Objection submission COM/2019/81 -

Environmental Authority EA0002207 Noise Limits will be exceeded for foreseeable future

## Attachment H3 - Noise plan Stage 6 (with correct Concrete Plant Noise Source identified)

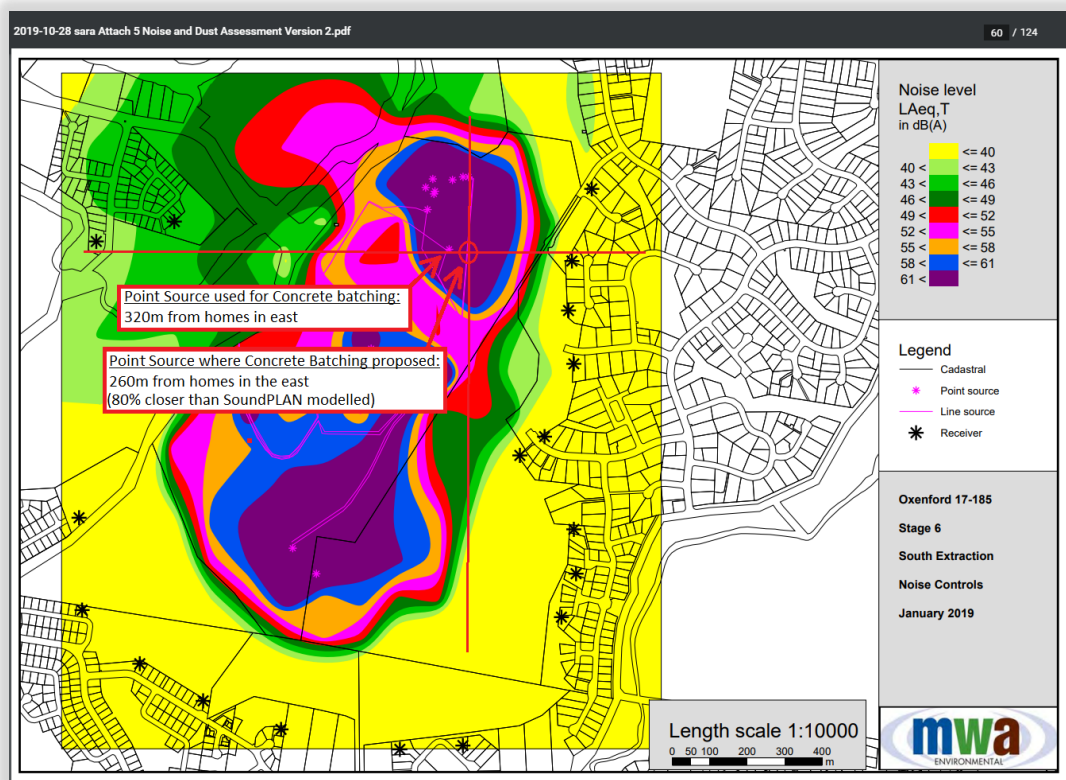
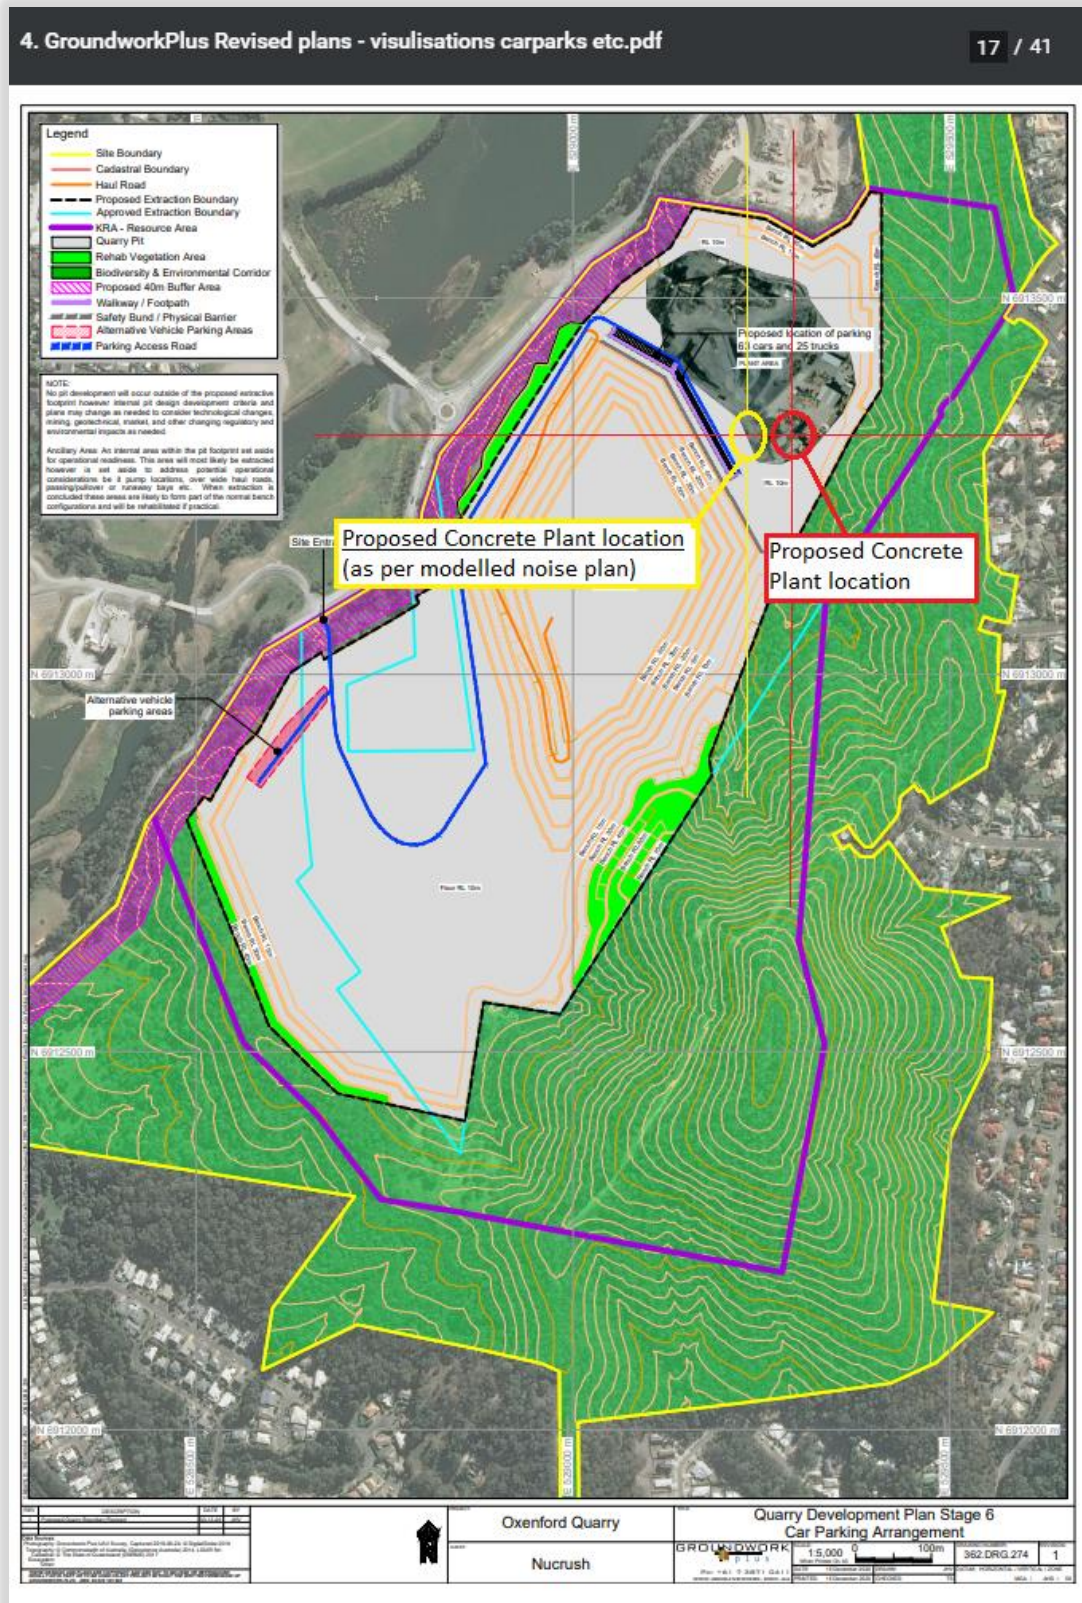
The submitted Noise Plan for Stage 6 is reproduced in Attachment H2. However, comparing the position of the Concrete Plant in attachment H1 and attachment H2 it can be seen that the noise plan has the concrete production plant in the wrong location and is in fact approximately 60 metres further left than it should be (Attachment H3). As in this location it would impede on the car parking area (Attachment H4) I assume the correct position is as shown in the '*Visualisation Stage 6 layout plan*' (Attachment H1).

However, this means the Concrete production / batching noise source will be 260 metres from the closest '*noise sensitive places*', i.e. homes in Rosewall Place, as opposed to what would seem like a modelled 320 metres.

## Attachment H5 - Car Park and Concrete Plant shown together at 320 metres from Rosewall Place

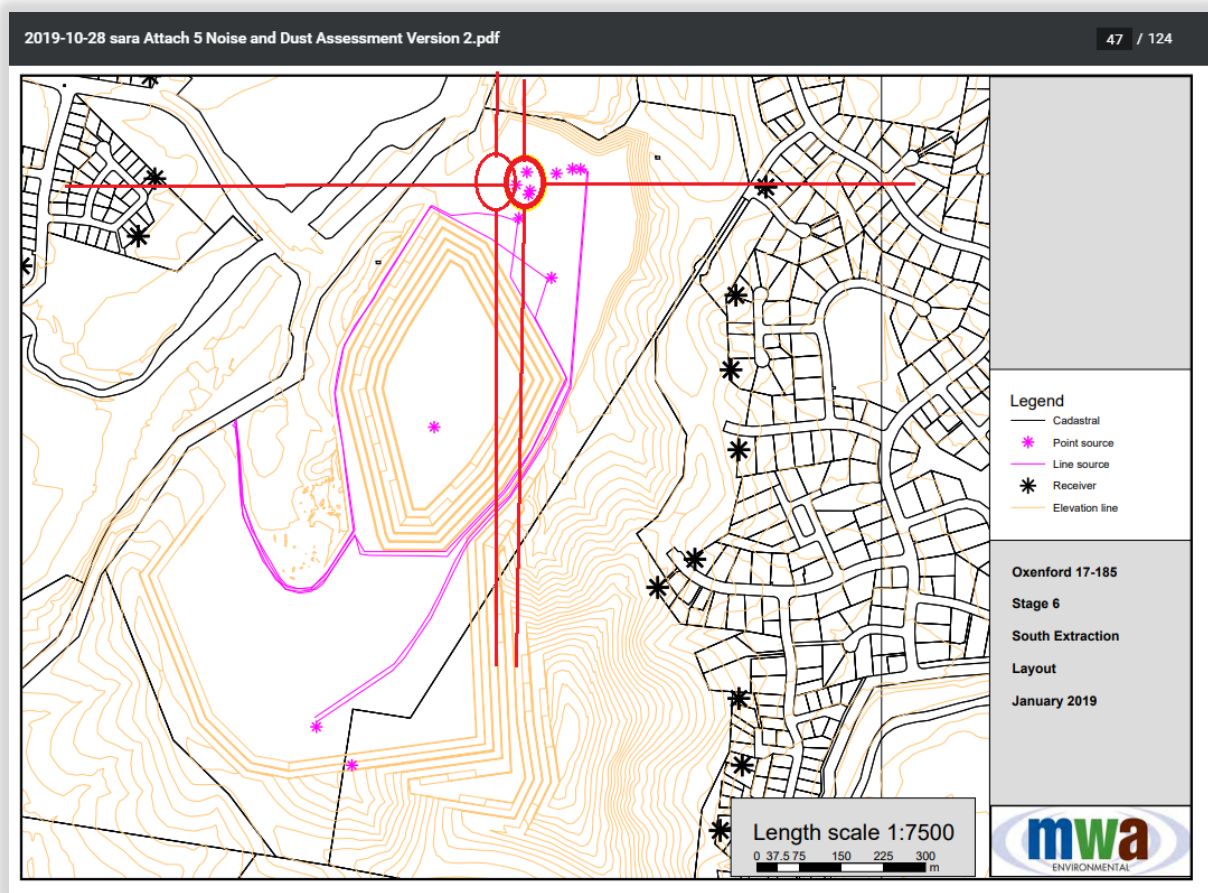
I have modelled the respective differences (Attachment H5). It is interesting to note that the difference between the '*Noise plan for Stage 6*' position for the concrete plant produces an estimated 54 dB(A) (Attachment H5) whereas the, what I believe is the correct proposed location, generates a higher estimated 56 dB(A) (Attachment H5). When the Main Processing Unit is also combined the estimated Noise levels at Rosewall Place will be a massive 59 dB(A) (Attachment H5). However, please note this is not including any of the haulage trucks or concrete trucks or loaders operating in the area.
